Installation Instructions

EC-17 Recall Changeout

This instruction sheet is intended to provide the necessary information to change out the EC-17 Antilock Controller assembly as a part of a recall campaign.

FIGURE 1 - OLD AND NEW REPLACEMENT ABS EC-17 CONTROLLERS

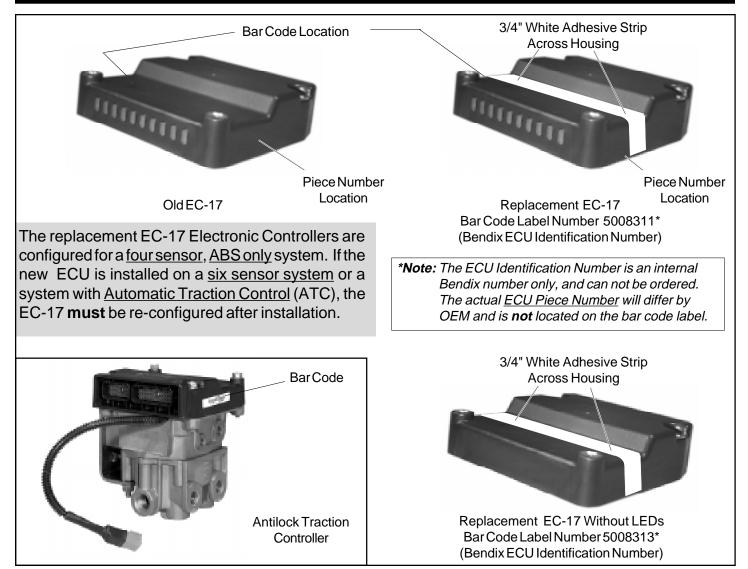
- 3. All EC-17 controllers without a white adhesive strip are suspect for possible changeout. The current production and recall replacement EC-17 controllers will have bar code ECU identification number 5008311 (with LEDs) or 5008313 (without LEDs) located on the side of the housing. The piece numbers will be in one of the following two series of numbers, either 5008XXX or 5009XXX. These numbers are pin stamped into the housing of the controller and may be more difficult to read. See Figure 1 for the location of the bar code label and stamped piece number.
